**PVC CLAYPOOL BUILDING SCOPE DESCRIPTION**

UPDATE 3/20/19

The following list of scope items is to be used together with the attached DSA approved set of plans.

**CLAYPOOL BUILDING RECONSTRUCTION**  
PALO VERDE COLLEGE, NEEDLES CENTER  
PALO VERDE COMMUNITY COLLEGE DISTRICT  
725 WEST BROADWAY STREET, NEEDLES, CALIFORNIA 92363

SHEET NO.  
**A6.2**  
 SHEET OF

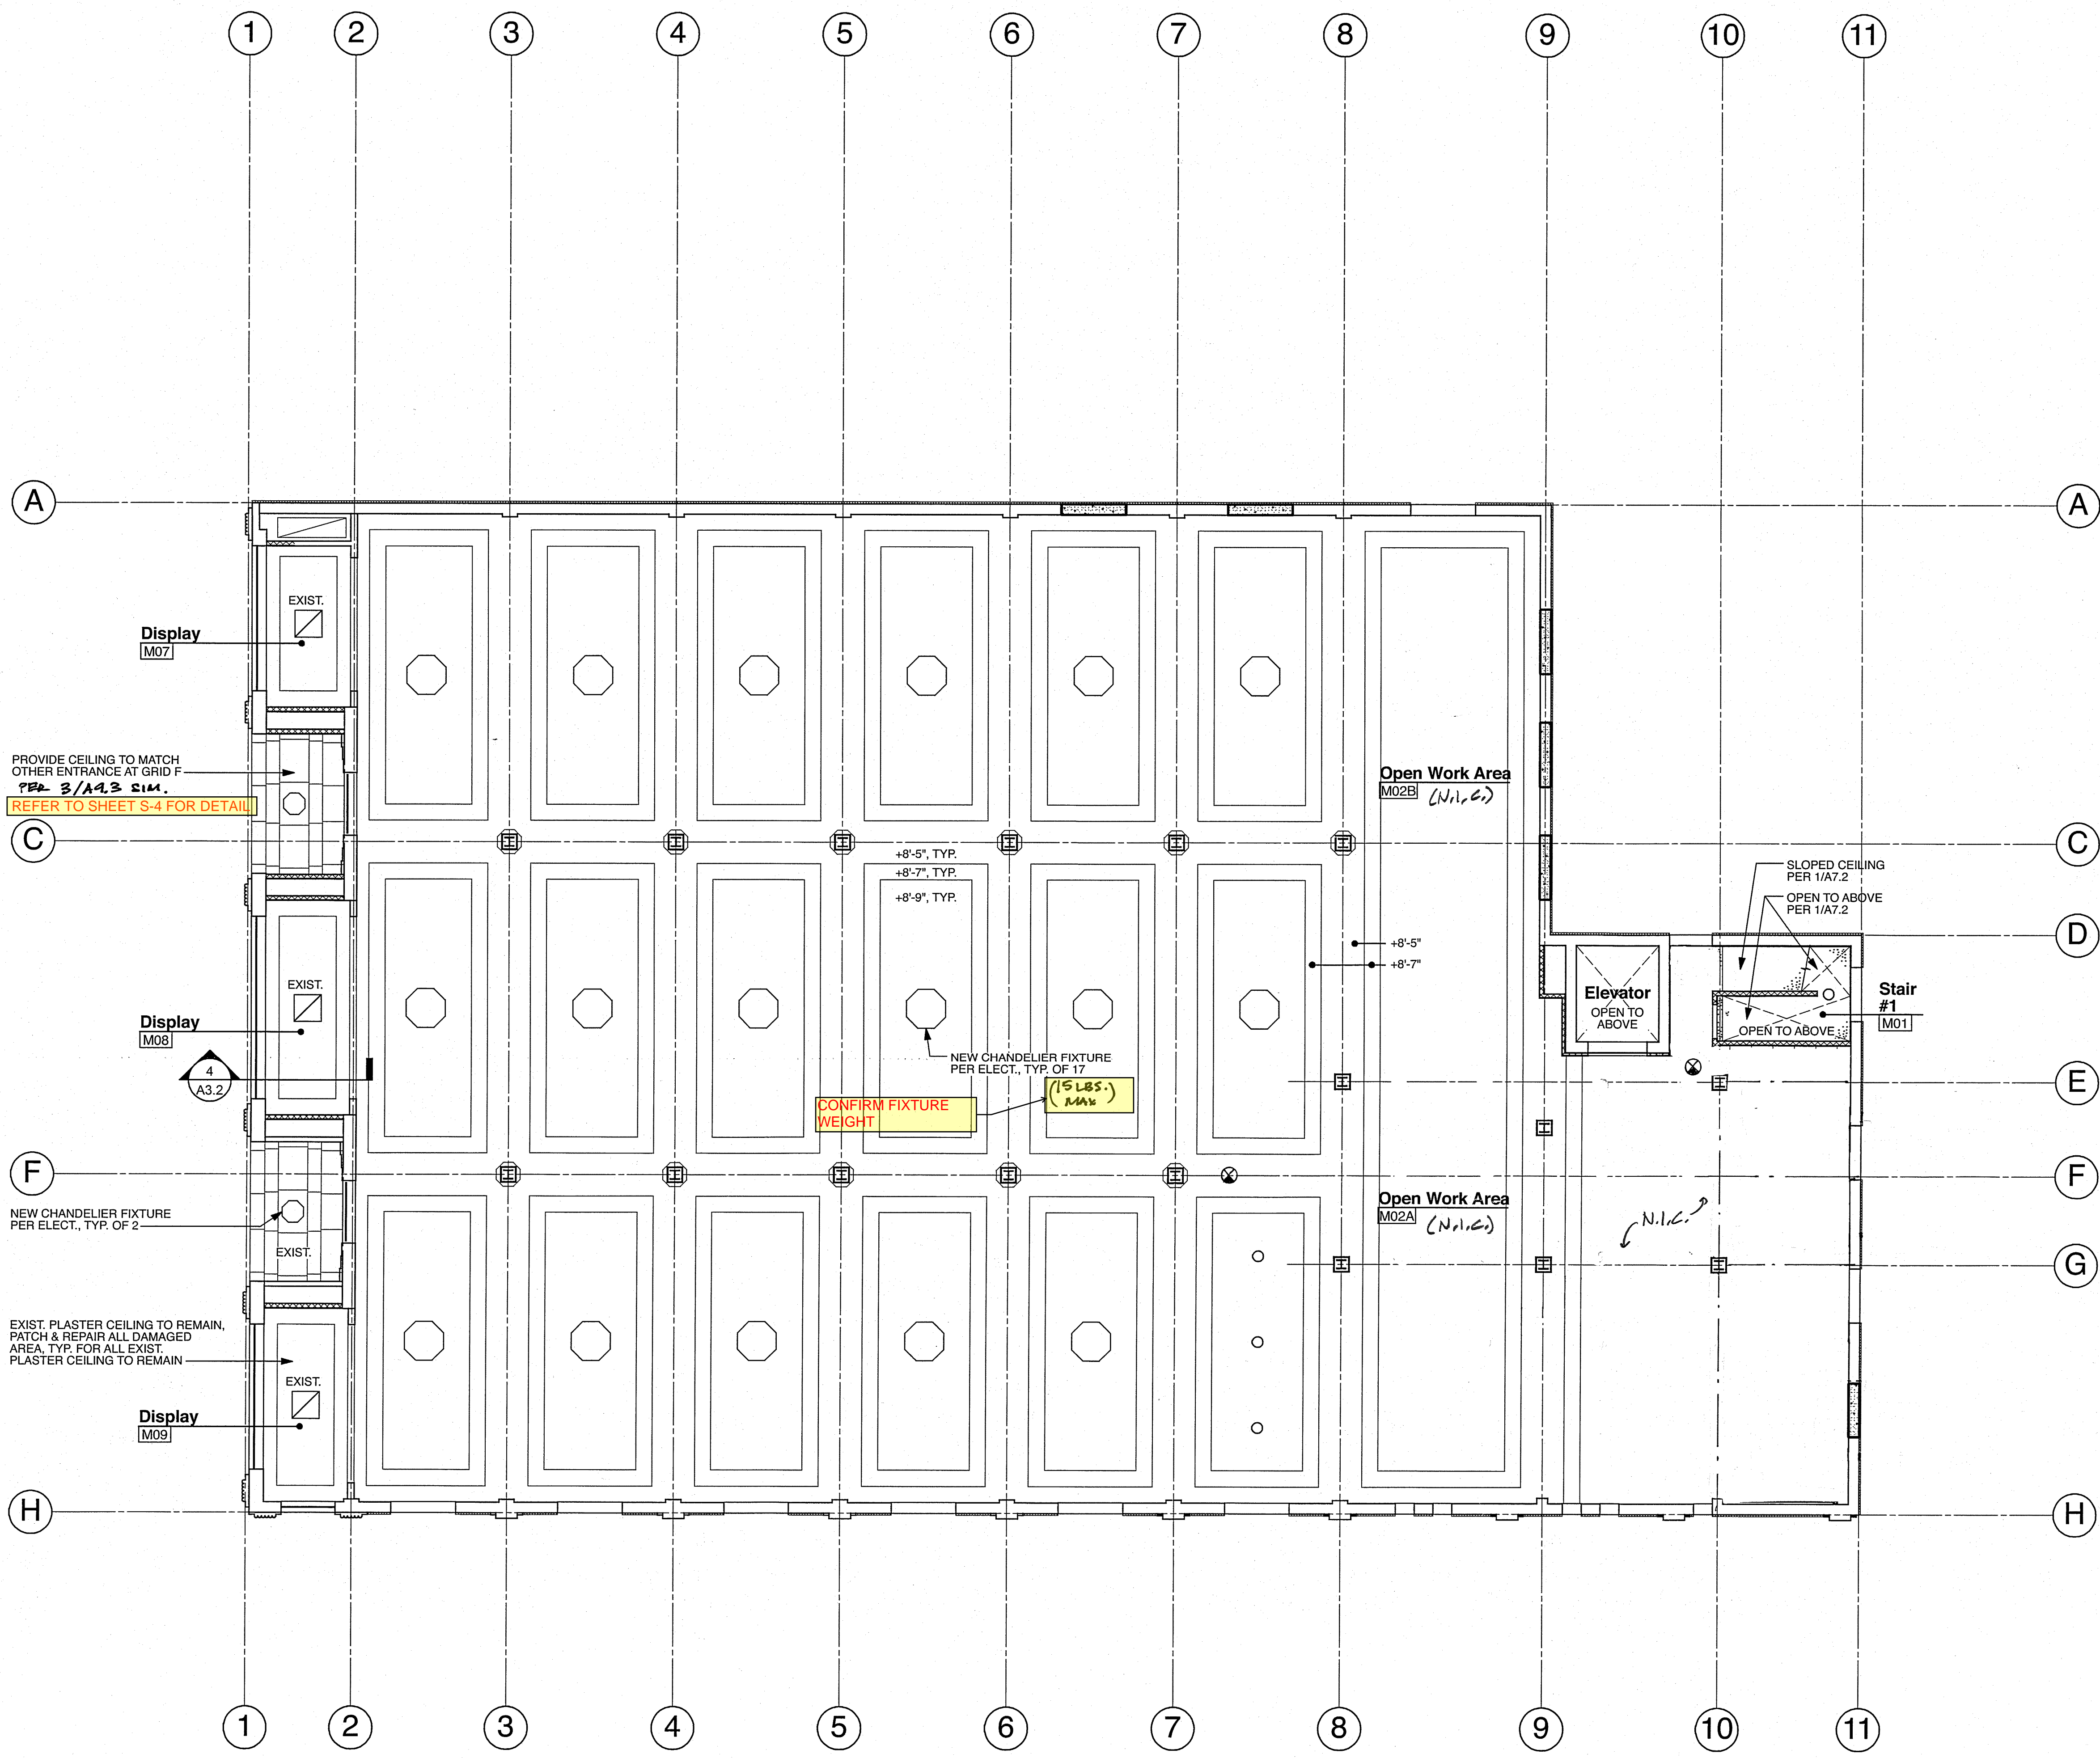
A-012	A6.2	Grids 9-C, 10-D & 7-F	DSA set shows addition of (3) directional emergency egress signs	INSTALL THREE NEW DIRECTIONAL EMERGENCY EXIT SIGNS PER APPROVED PLAN	Coordinate with electrical	N/A
A-013	A6.3	Grids 6-E	Confirm pendant light fixture weighs 15 lbs max. per added note on DSA set	<b>ALLOWANCE #2: CONTRACTOR TO DETERMINE EXISTING ATTACHMENT DETAIL AND SUBMIT TO AOR AND IOR FOR REVIEW. CORRECTIVE MEASURES MAY BE REQUIRED TO BRING EXISTING ATTACHMENT INTO COMPLIANCE</b>		Upon further investigation it was determined that the fixtures weigh 30 pounds. Contractor to open ceiling to verify existing attachment, Allowance.
A-015	A7.1	8/A7.1	Handrails are missing at two steps leading to stairwell door	Install handrails per approved plans		N/A
A-016	A7.1	10/A7.1	Non-accessible exit signage is missing per added note on DSA set (CBC 1117.5.B.1)	Install signage per approved plans		N/A
A-017	A7.3	3/A7.3	DSA added 1/2" max dimension between floor and cab transition. Field measurement indicates 1"-1.5" existing condition.	Contractor to consult with elevator manufacturer to provide corrective measures to comply with 1/2" maximum dimension as indicated on approved plans.		N/A

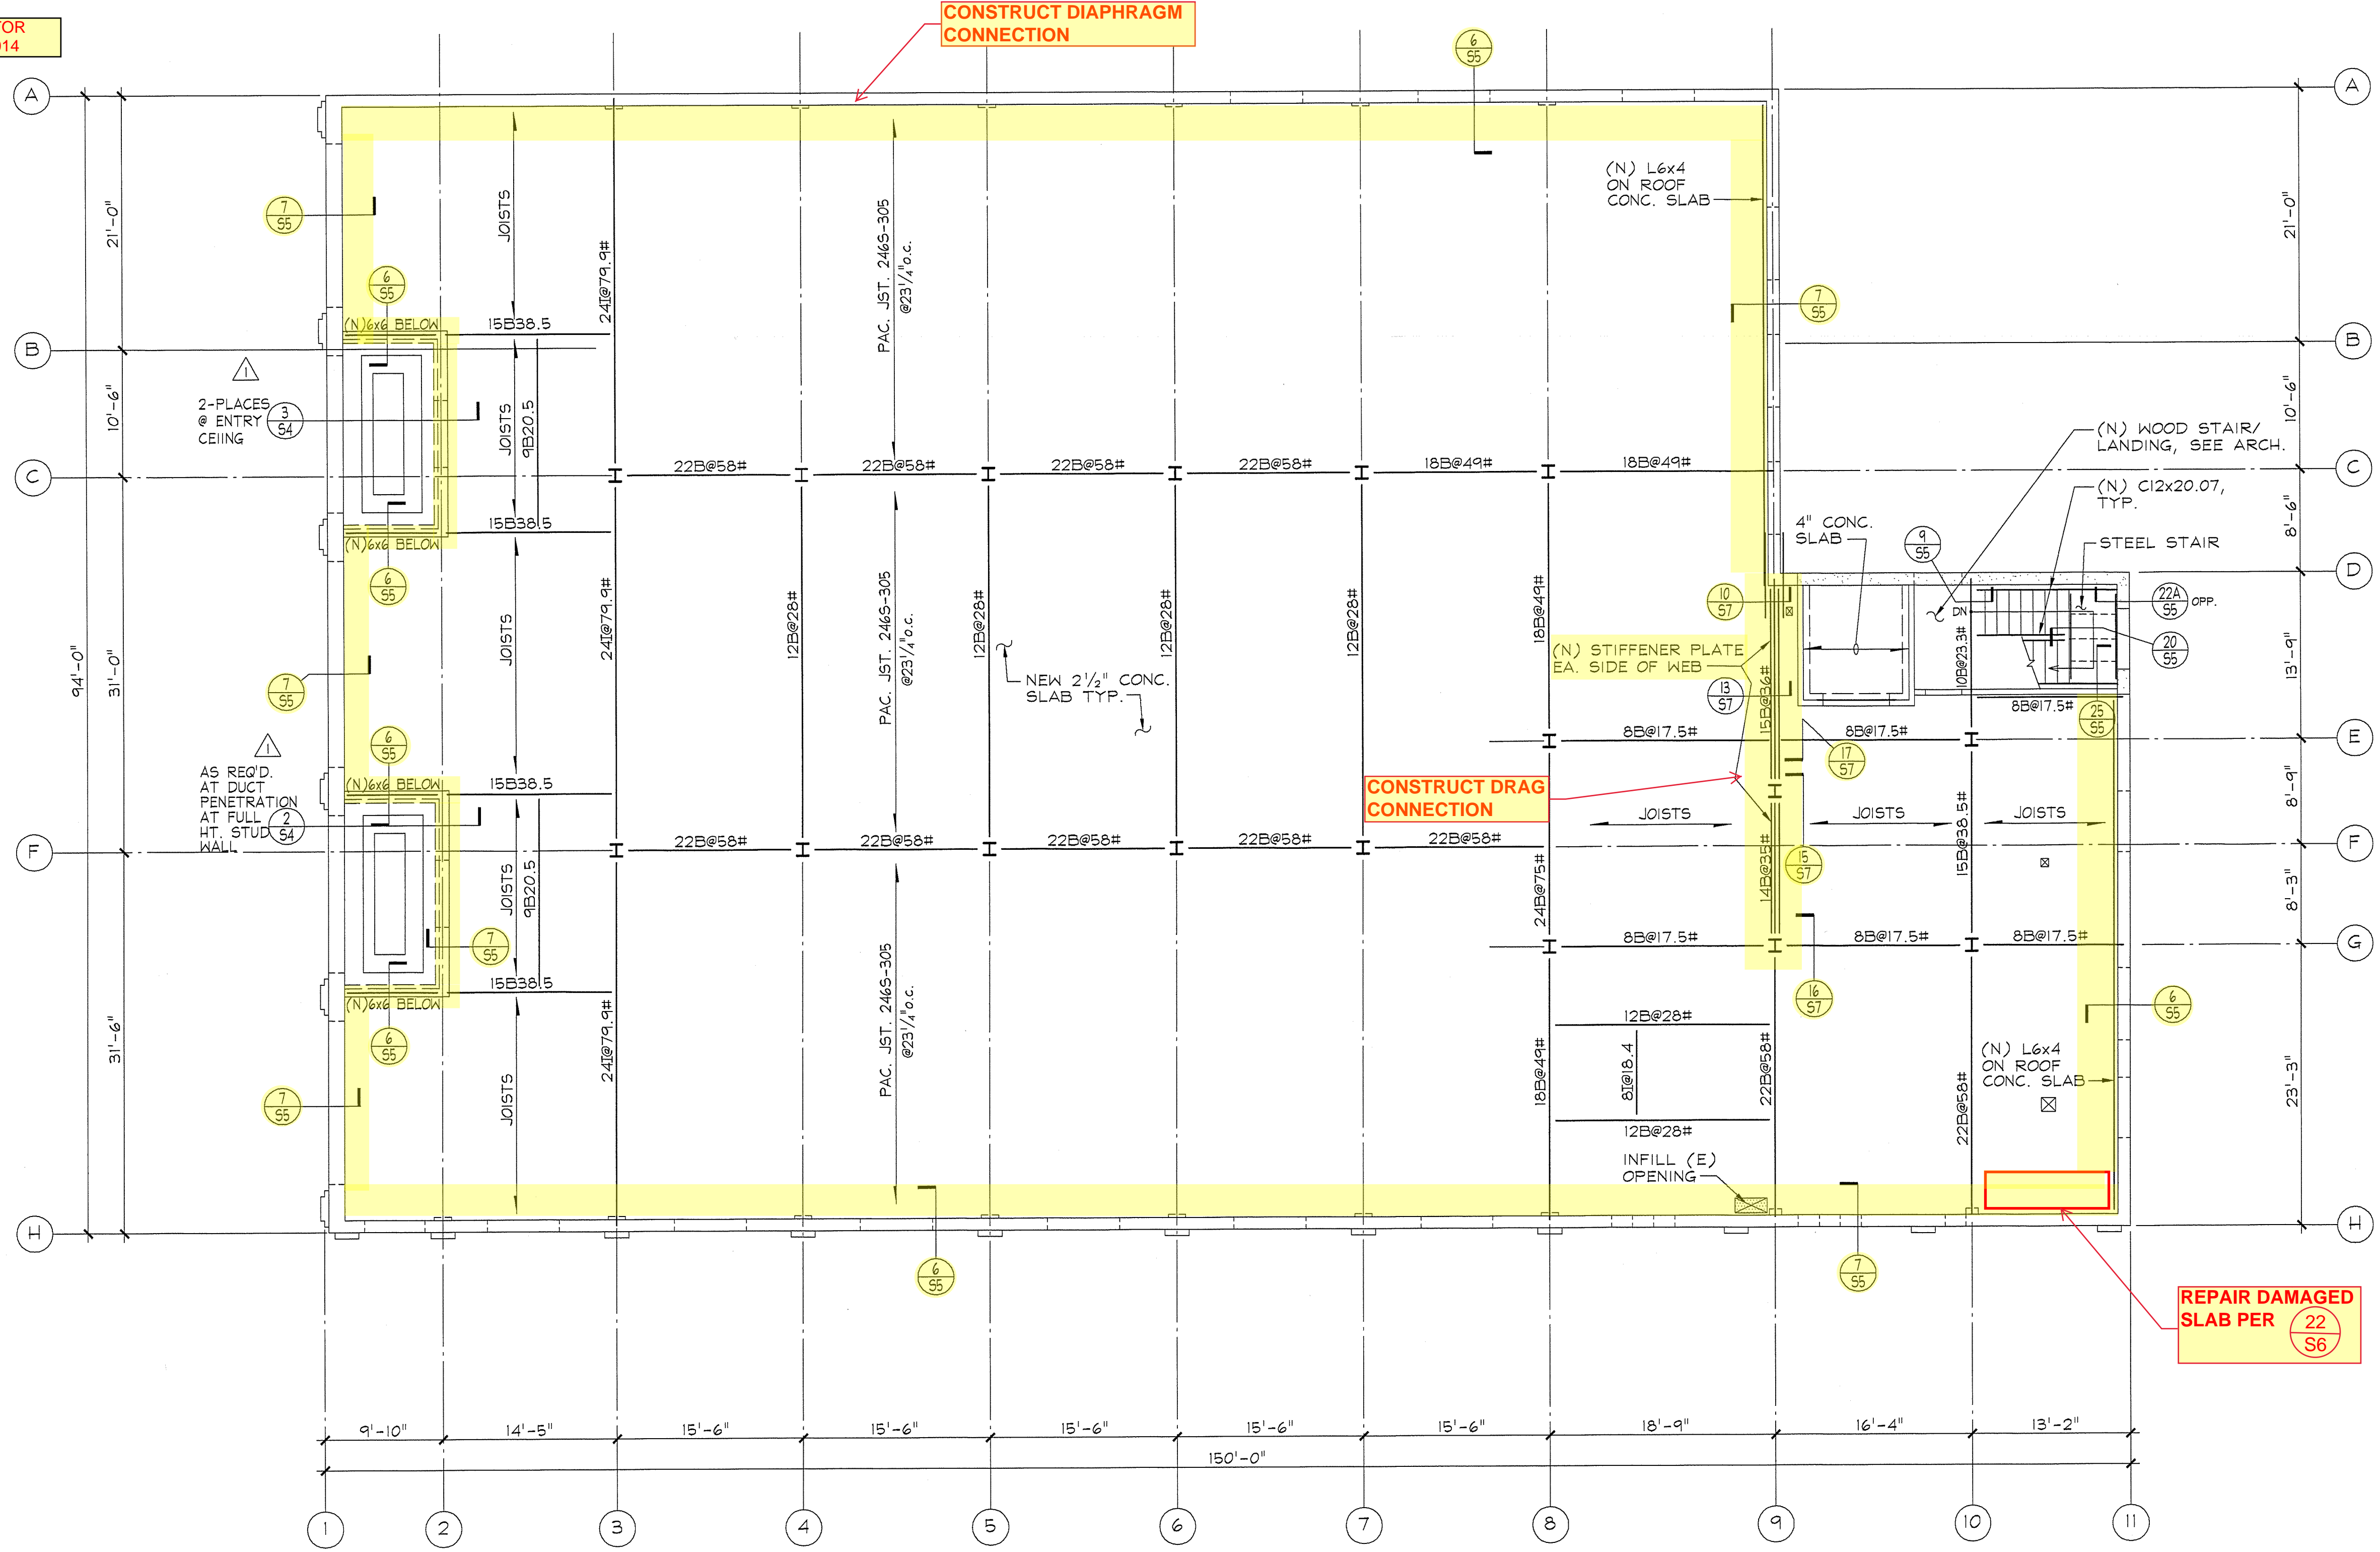
<b>STRUCTURAL</b>						
S-002	S-3	Grids 3 to 4 & Grids A to B	Retaining wall tie-back per Details 12/S-7 has not been constructed.	Construct tie-back per DSA approved drawings.	Will require removal and re-construction of some existing elements.	N/A
S-003	S-3	Grid 9 & Grids A to G	Drag connections shown in Details 10, 13, 15, 16, 17, and 18 / S-7 have not been constructed.	Construct drag connections per DSA approved details.	Will require removal and re-construction of existing finish elements.	N/A
S-004	S-3	Grids 10 to 11 & Grids D to H	Diaphragm strengthening steel plate has not been constructed per Details 5/S-6 and 14/S-6.	Construct diaphragm strengthening per DSA approved details.	Will require removal and re-construction of existing finish elements.	N/A

S-005	S-3	Grids 8 to 9 & Grid F	New 2x12 @ 8" o.c.	Comply with Detail 12/S-6 if not constructed per DSA approved drawings.	None	Observed 2x12's @ 16" o.c.
S-006	S-4	Grid H & Grids 10 to 11	Damaged slab	Repair damaged slab per DSA approved Detail 22/S-6.	Will require removal and patching of existing roofing.	N/A
S-007	S-4	Entire Roof Perimeter	Diaphragm connection Details 6/S-5 & 7/S-5	Install perimeter connection angle at top of roof per DSA approved Details 6/S-5 and 7/S-5.	Will require removal and patching of existing roofing.	N/A
S-008	S-4	Grid 9 from Grids D to G	Drag connections shown in Details 10, 13, 15, 16, and 17 / S-7 have not been constructed.	Construct drag connections per DSA approved details.	Will require removal and re-construction of some finish elements.	N/A
<b>FIRE SPRINKLER</b>						
FS-004	FP: 1 OF 1	C/6-8	Ends of branch lines not furnished with restraints (3) in sewing lab storage room.	Install restraints at affected piping.		N/A

I-006	S-3 (1st Floor Frm'g)	8.5 / F	Verify 2x12 @ 8" O.C.	Add 2x's per approved plans		Existing is framed 2x12 at 16" O.C.
I-007	S-3 (Mezzanine Floor)	as occurs either side of E	Verify stiffener plates along Line 9	Add work shown on approved plans		Mezzanine floor level - No column/beam work shown in Details 15, 16, 17 /S-7 is completed (Similar to I-015)
I-013	S-3 (Mezzanine Floor)	Line 10 from E-G (mezzanine plan)	Drag (Floor Span) connections (5/S-6)	Add MST126 as shown wherever 5/S6 is required		All other features shown for joist-framing in Section 5/S6 appeared to be in place
I-015	S-4 (Roof Plan)	Line E-G on Line 9	Field verify ext'g condition per note on 15,16,17/S7	Add work shown on approved plans		Mezzanine above-ceiling (roof plan) level - No column/beam added plate work shown in Details 15, 16, 17 /S-7 is completed (Similar to I-007)
I-018	S-3 (Mezzanine Floor)	Approx. D.75 to H, between 10 & 11	1/4" Steel Pl.	Add 1/4" plate as indicated in 5/S6		NONE

I-019	S-3 (Mezzanine Floor)	Lines H & 11	Perimeter angle per 5/S6 and Mezzanine floor plan	Add L 4x4 where indicated along Lines H and 11 of Mezzanine plan (ref: 5/S6)		NONE
I-020	S-3 (Mezzanine Floor)	Line 9	(N) L 6x4	Add angle per plan		ref: Detail 18/S7
I-021	S-3 (Mezzanine Floor)	At 9 & D (both sides of wal)	Strapping	Add 1/2" x 7" strp as shown per details. Repair EIFS finish.		ref: Detail 10/S7
I-023	S-3 (1st Floor Frm'g)	Stair #2	Framing shown on DSA plan for framing beneath Stair #2 as "(N) 2x8 @ 6" O.C. below"	<b>ALLOWANCE #5: PRESUMED WALL WILL NEED ADDITIONAL JOISTS AND RE-FINISH CEILING OF B-15</b>		May be observed by opening gyp-board enclosed area of ceiling in Room B-15 (Sewing Room) from below.
I-024	S-4 (Roof Plan)	Parapet	Perimeter angle as indicated	Add continuous L6x4x3/8 and related anchorage to structure as shown		ref: Details 6/S5 and 7/S5
I-025	A2.1	Rated Corridor	Column wrap (13/A9.2, sim.) is open at the level of the beam bottom flange at several locations on the Classroom side of wall.	Close in with gyp-board and fire-caulking		It is not clear how this is fire-blocked; appears that flame or smoke could enter the wall cavity via this path

CONSULTANT
